POST TENDER ADDENDUM

JLG 16098 Bottineau Ridge II Apts

RE: post tender addendum 04

Issued: April 3, 2018

**FIRST FLOOR PLAN -
WEST -
POWER/SYSTEMS**

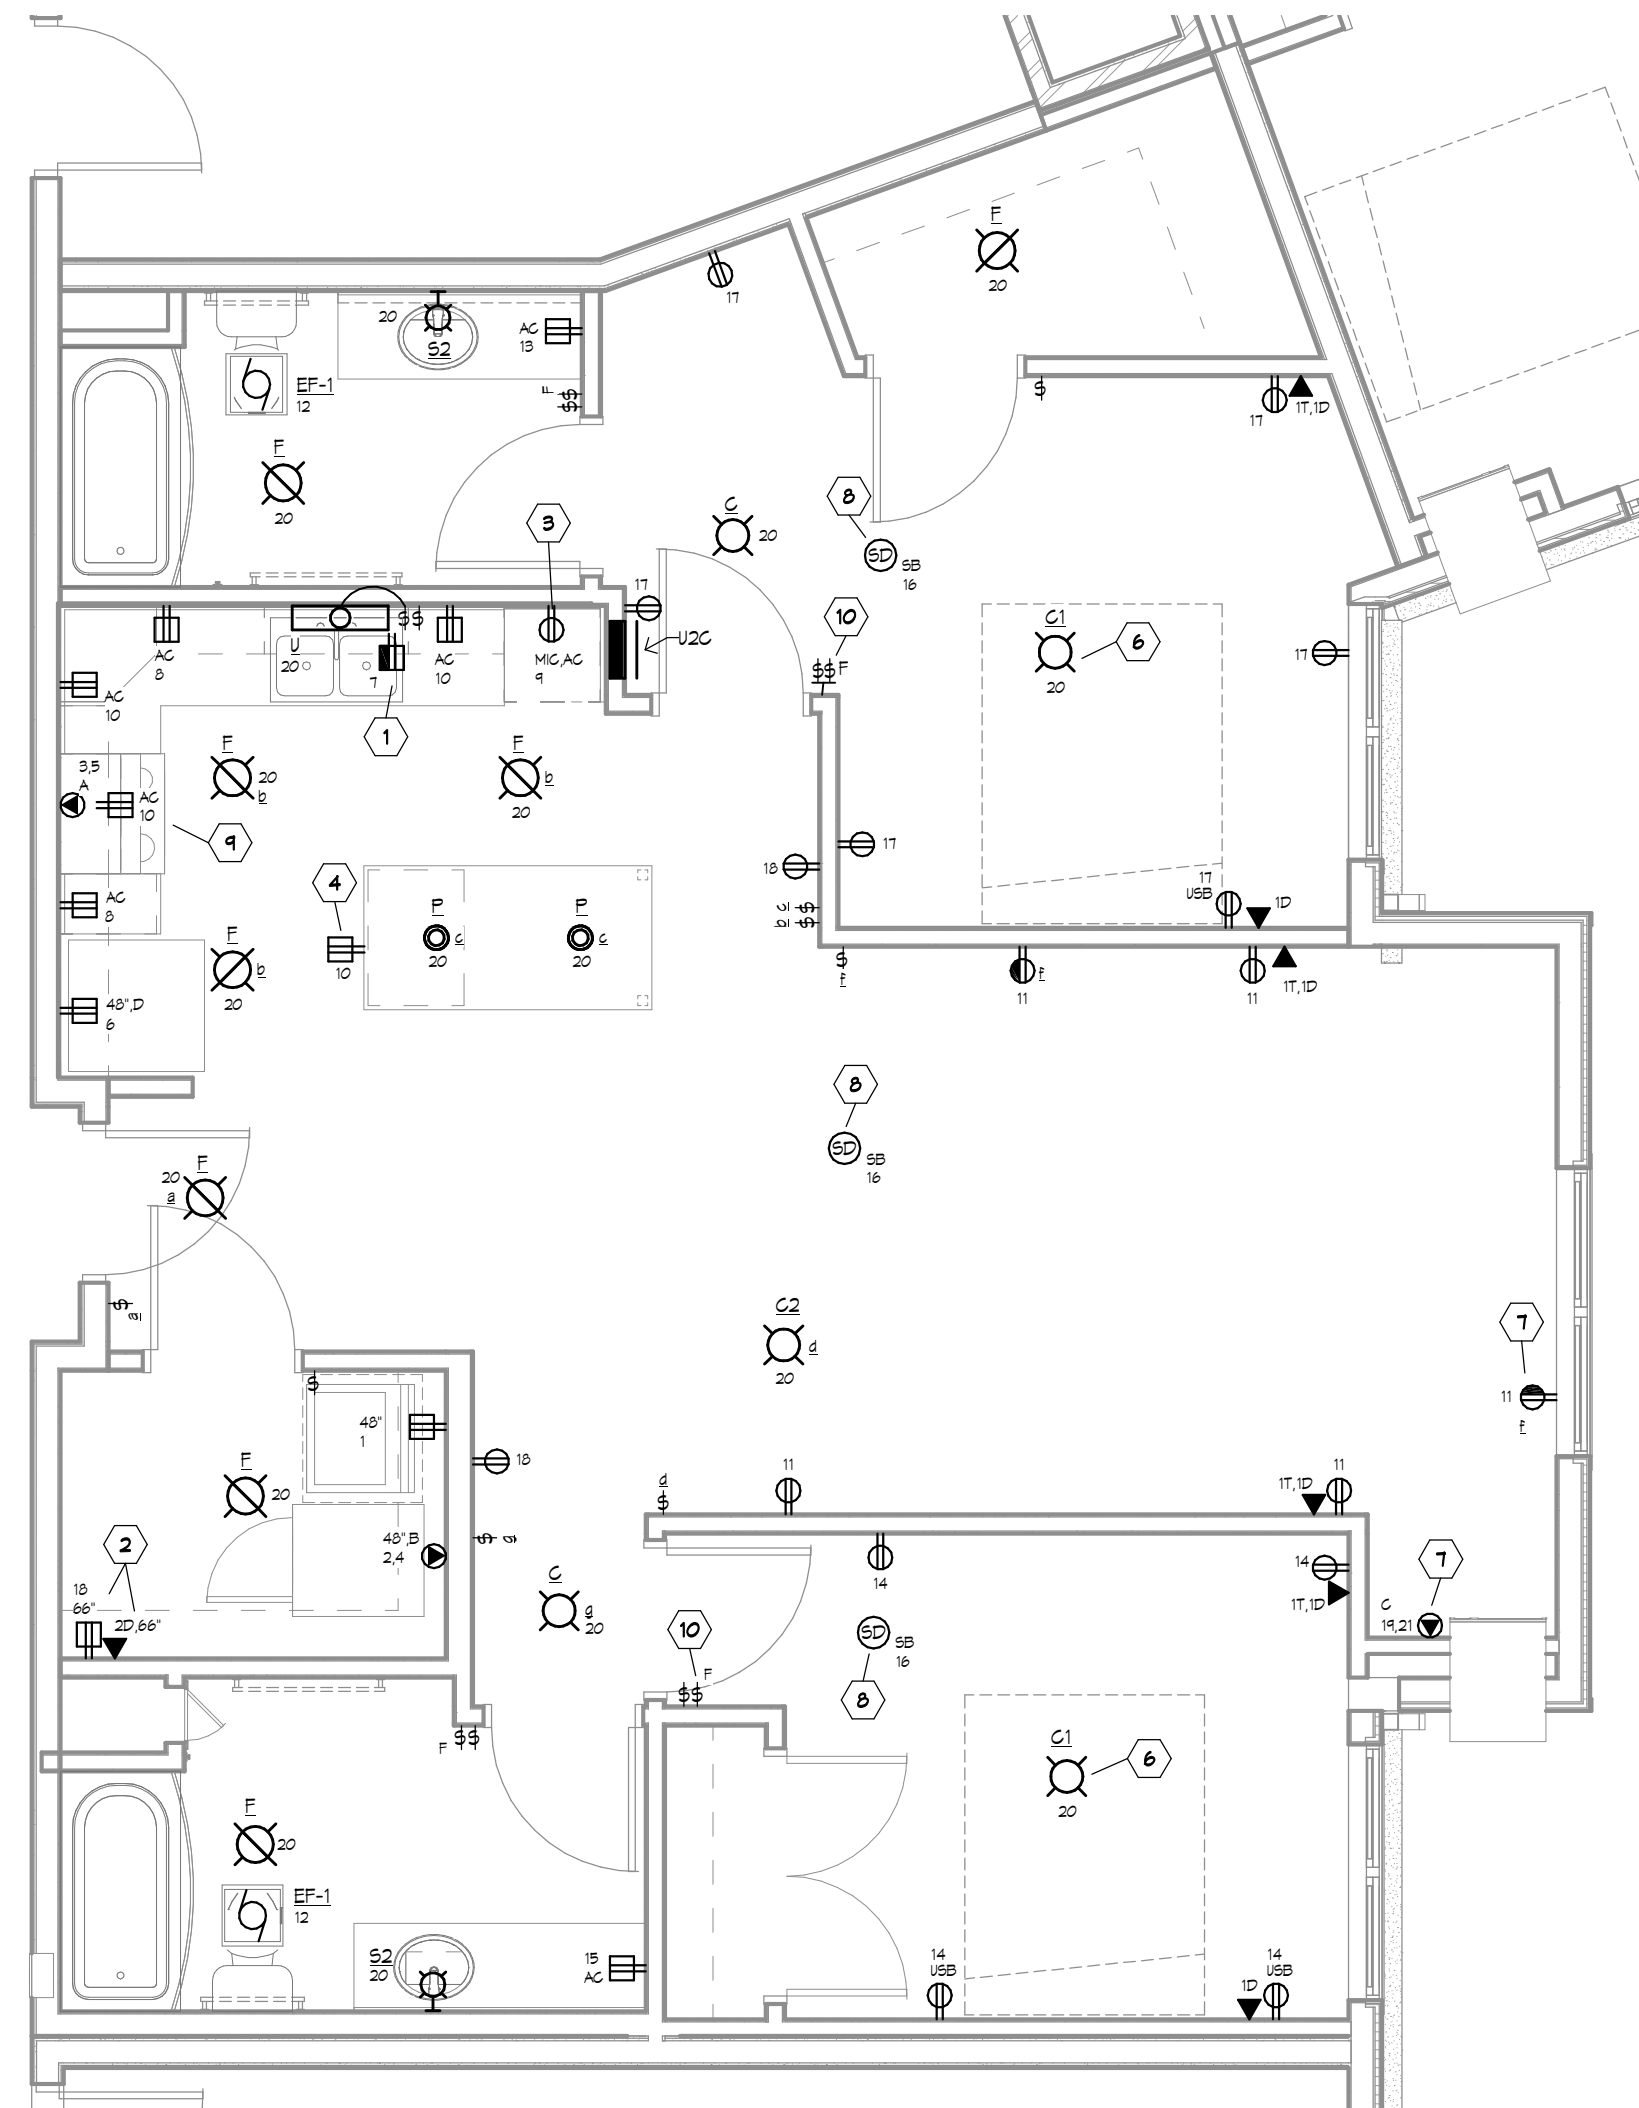
5. E202 FIRST FLOOR PLAN – WEST- POWER/SYSTEMS – See attachment.
 - o Power & Systems Sheet Notes, add note 6.
6. E300 LARGE SCALE UNIT PLANS – ELECTRICAL – See attachment.

DATE
12/11/2017
PHASE
CONSTRUCTION
DOCUMENTS
PROJECT
ONE# 2016446
SHEET
E300
LARGE SCALE UNIT
PLANS - ELECTRICAL

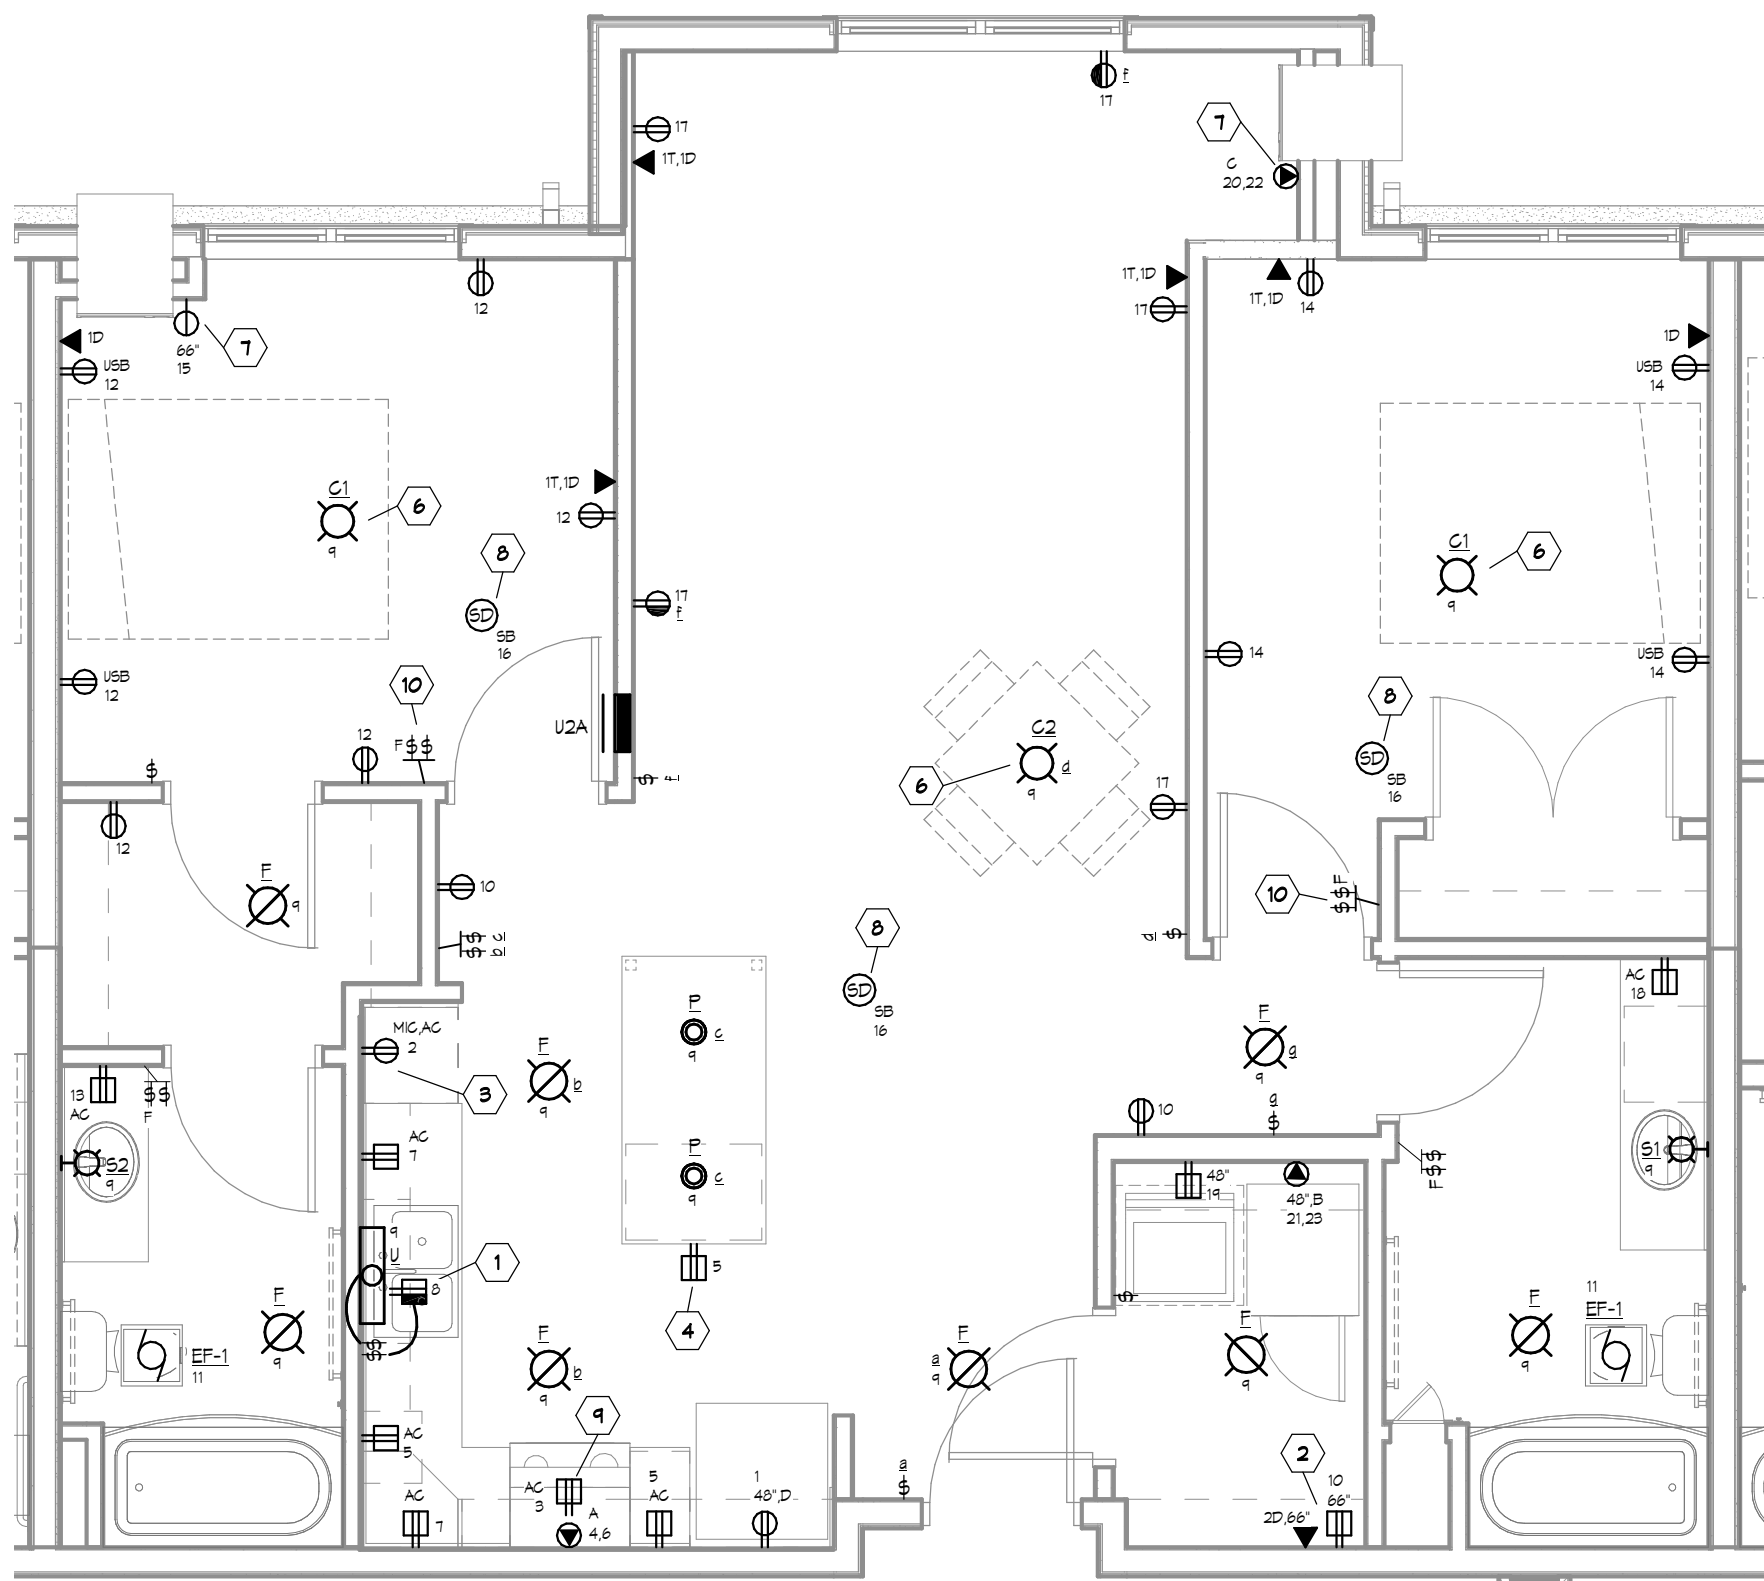
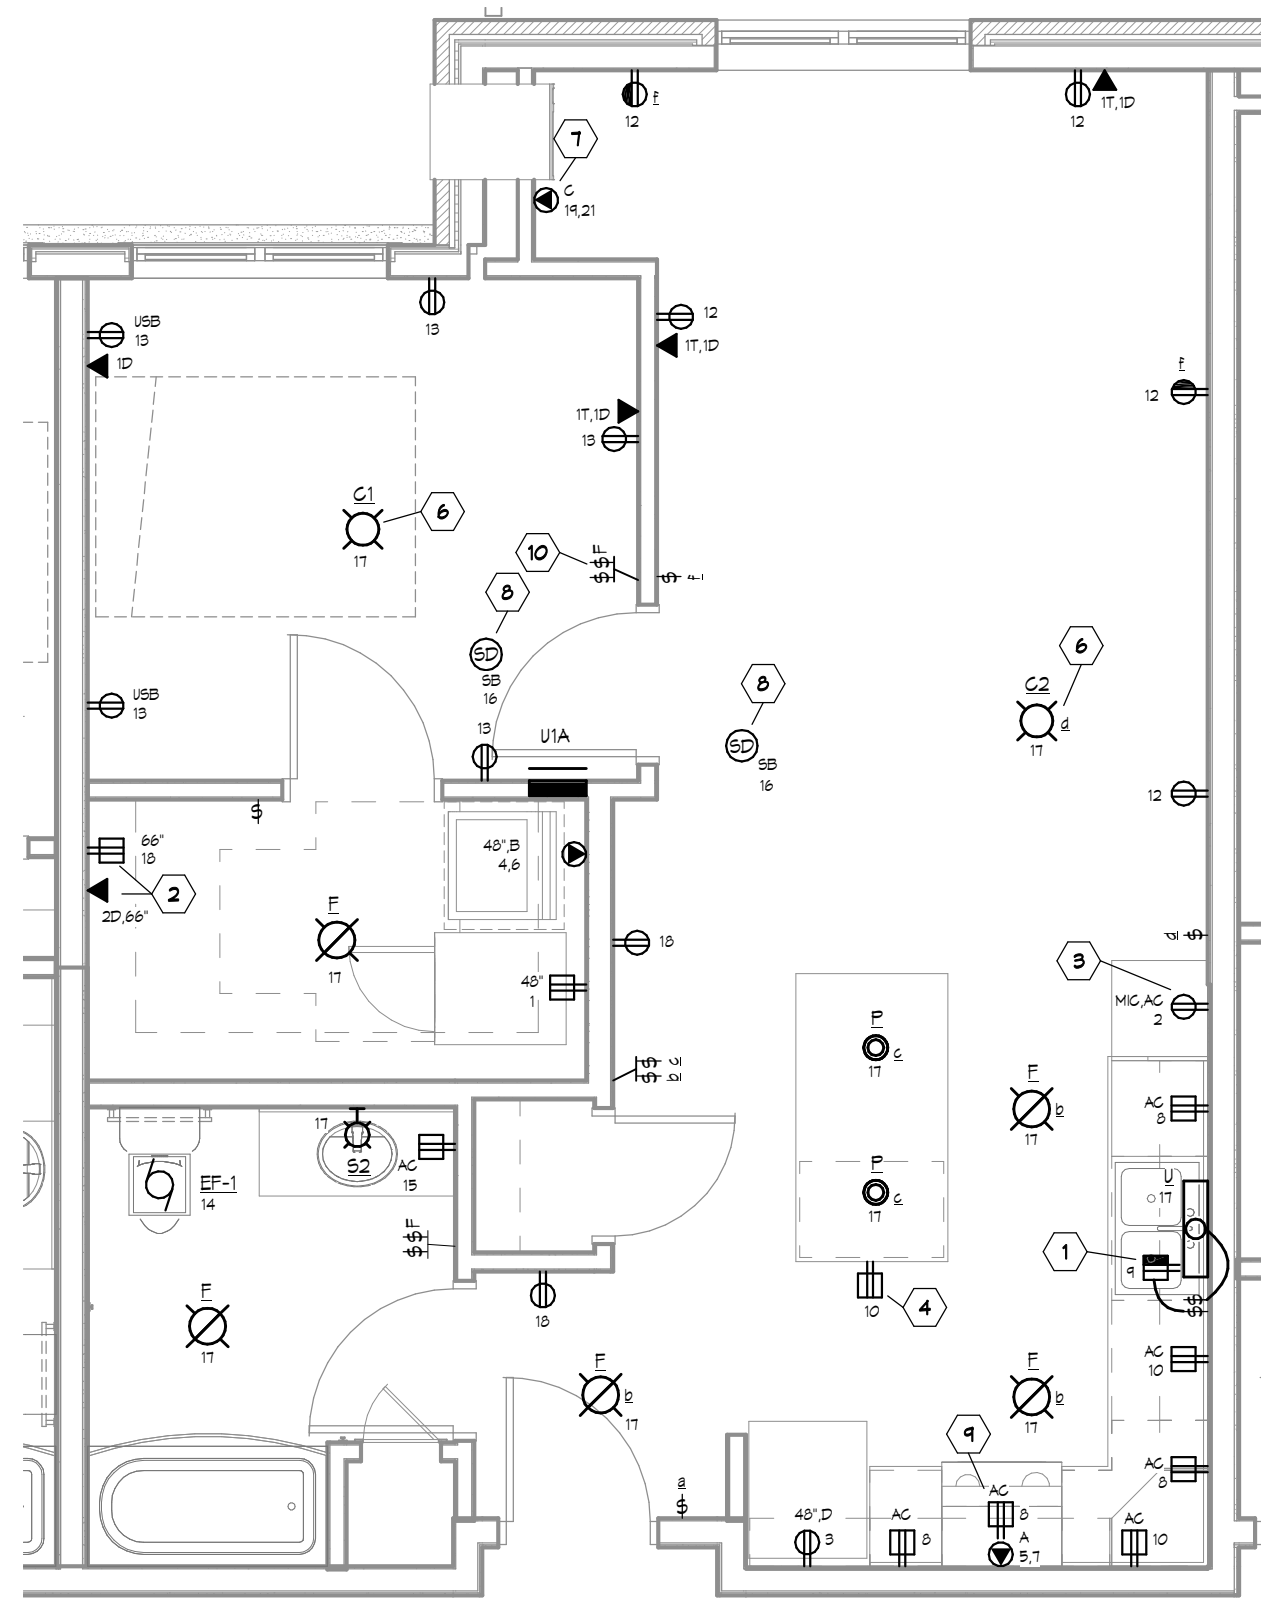
- o 1/4" Unit Elec. Sheet notes, revise note 8."
7. E301 LARGE SCALE UNIT PLANS – ELECTRICAL – See attachment.
 - o 1/4" Unit Elec. Sheet notes, revise note 8."

8. SMOKE DETECTORS IN FIRST FLOOR APARTMENT UNITS SHALL BE TYPE 1 MONOXIDE/SMOKE DETECTION TYPE. UNDER ALTERNATE 1 MECHANICAL DESIGN, ALL UNITS TO BE COMBINATION CARBON MONOXIDE/SMOKE DETECTION TYPE.
